## MEMORANDUM

**SUBJECT:** Summary of Site Visit of Damco, Inc. Facility  
Mountain Home, AR  
FTN No. 050

**Damco, Inc. Site Plans - Nelson Engineering (March 1997)**

**Proposed Improvements for Damco, Inc. - Nelson Engineering (March 2014)**

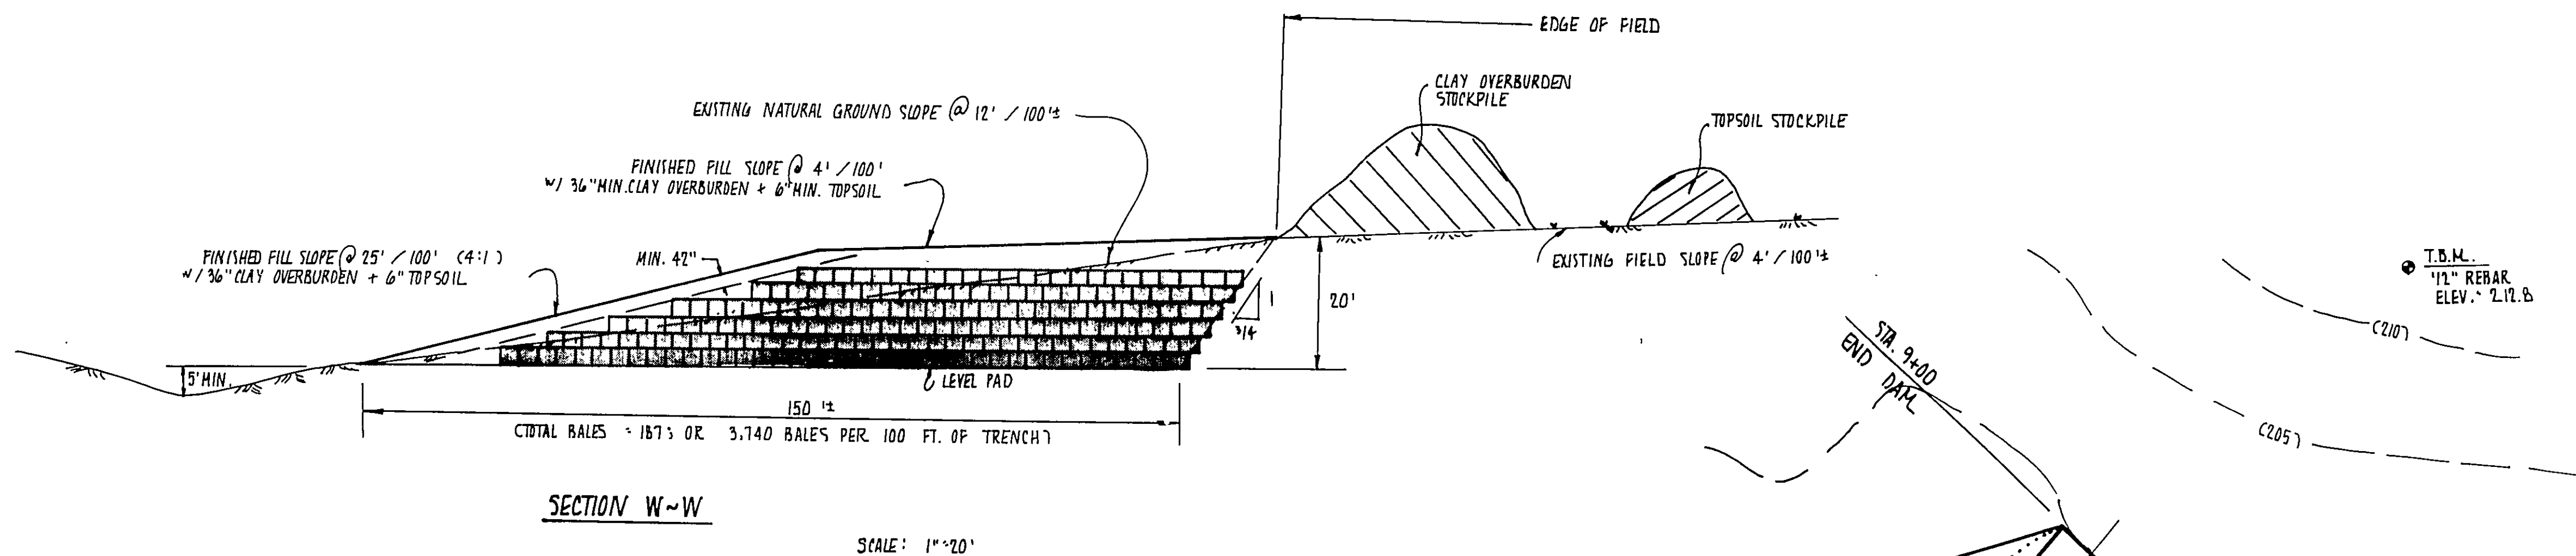
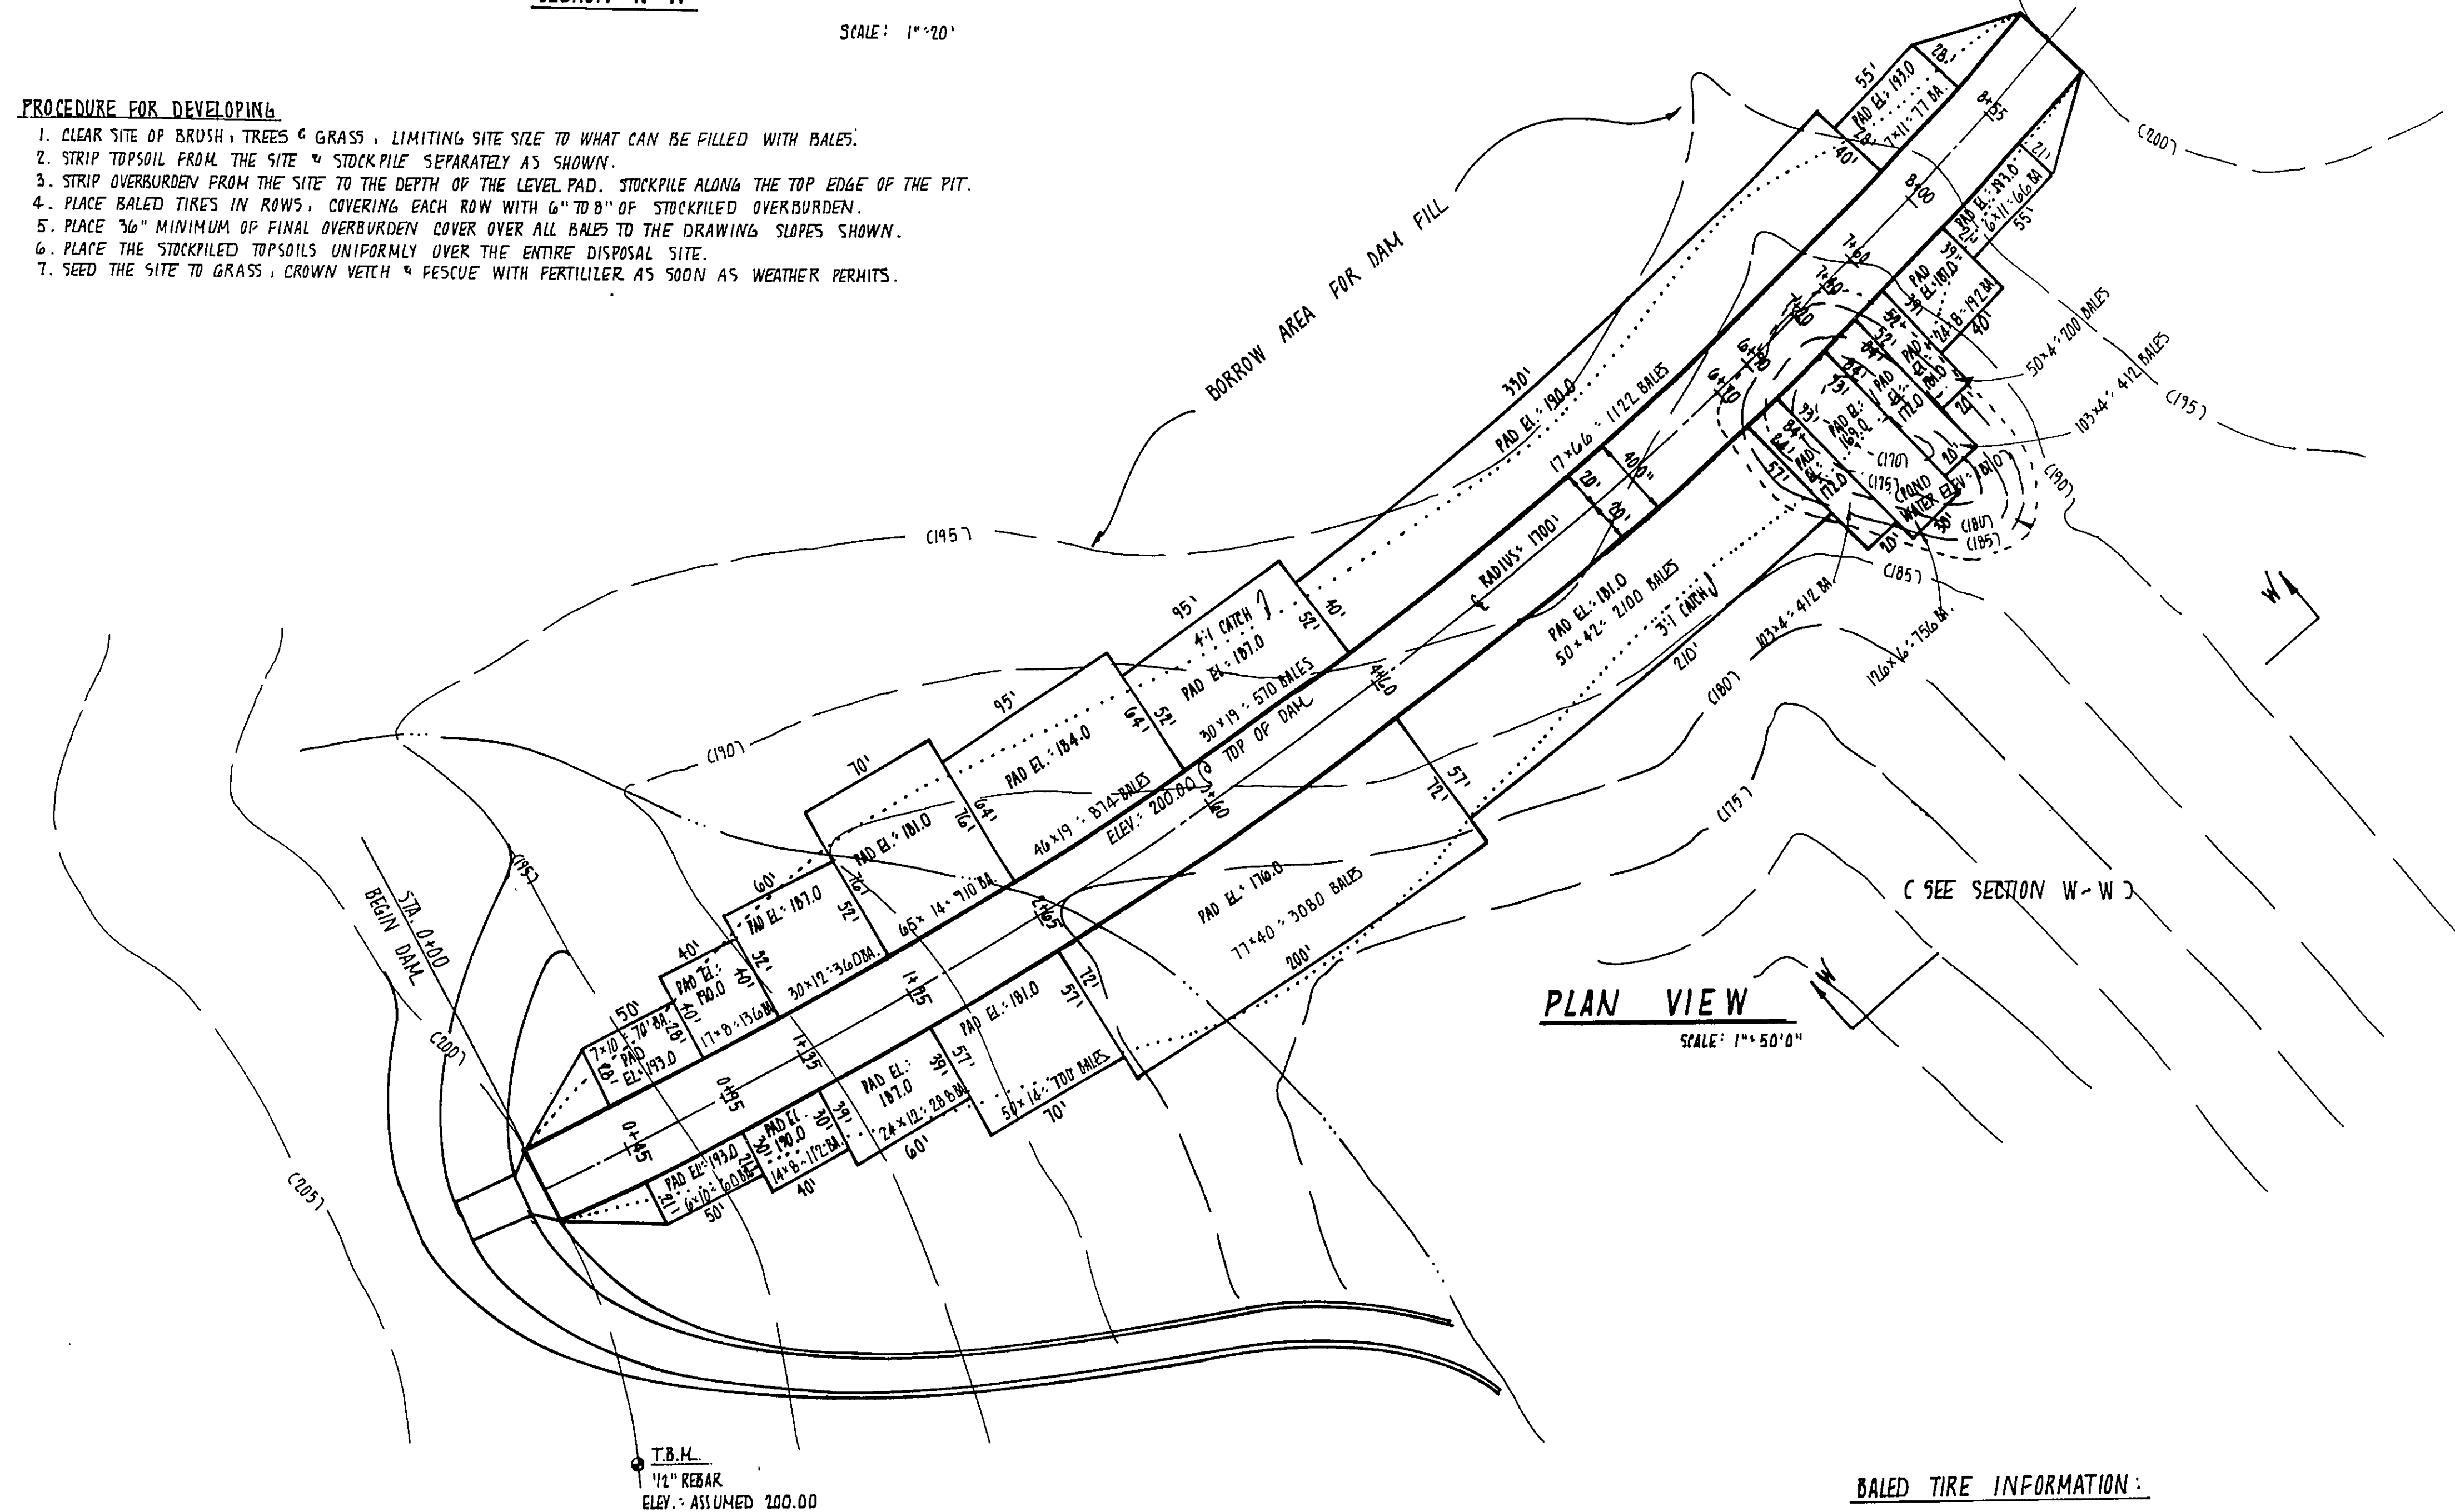
1. Waste tires are buried outside the limits shown on the original design plans as prepared by Nelson Engineering (1997; Attachment 1). Buried tires were identified on the southwest approach to the crest of the dam and the downstream side of the dam was much larger than designed due to extra waste tires.

2. The top (crest) of the dam is approximately the same width (40 ft) as shown on the original design plans. However, the crest is longer than designed (approximately 1,350 ft versus 900 ft). The surface of crest of the dam did not show any signs of settlement or rutting (see Photo 1; Attachment 2)

3. According to the design plans, the downstream side of the dam was supposed to have been constructed at a slope of 3H:1V and was to be approximately 72 ft (horizontal) from crest to toe. However, the downstream side has three benches (terraces) and the slope is much longer than originally designed (approximately 380 ft including benches and slopes between benches). The upper bench is about 100 ft wide and is about five rows of tire bales high (about 15 ft). The middle bench is about 180 ft wide and about nine rows of tire bales high (about 27 ft). The lower bench is approximately 50 ft wide and about two rows of tire bales high (6 ft). Photos 2 through 5 present terraced downstream side of dam.
